L-MT-16-041
10 CFR 50.90

Monticello Nuclear Generating Plant
Docket 50-263
Renewed Facility Operating License No. DPR-22

License Amendment Request for AREVA Extended Flow Window
Supplement to Address Power Distribution Uncertainties (TAC No. MF5002)

**B2.1.1-4
B2.1.1-6
Inserts**

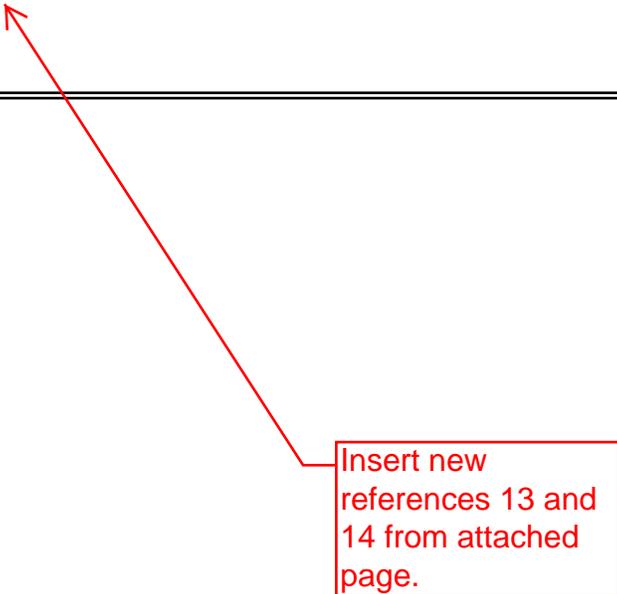
and 2.1.1.3

Insert A (next page)

2.1.1.3 Reactor Vessel Water Level

However, based on reduced confidence in power distribution uncertainties in the extended operating domain (Extended Flow Window), TS Safety Limit 2.1.1.3.c includes a penalty of 0.03 that must be added to the SLMCPR (i.e., the SLMCPR calculated with AREVA methods and uncertainties) when the ratio of core power to core flow equals or exceeds 42 MWt/MLb/hr in the EFW domain. This threshold is provided in Reference 13, and the basis for the 0.03 penalty is provided in Reference 14. This threshold is appropriate for MNGP because it represents a sufficiently high power-flow ratio that is outside the normal range of plant maneuvering. In this way, the SLMCPR adder (0.03) will not adversely affect full power operation. The adder (0.03) is not imposed on single-loop operation because single-loop operation is prohibited in the EFW region.
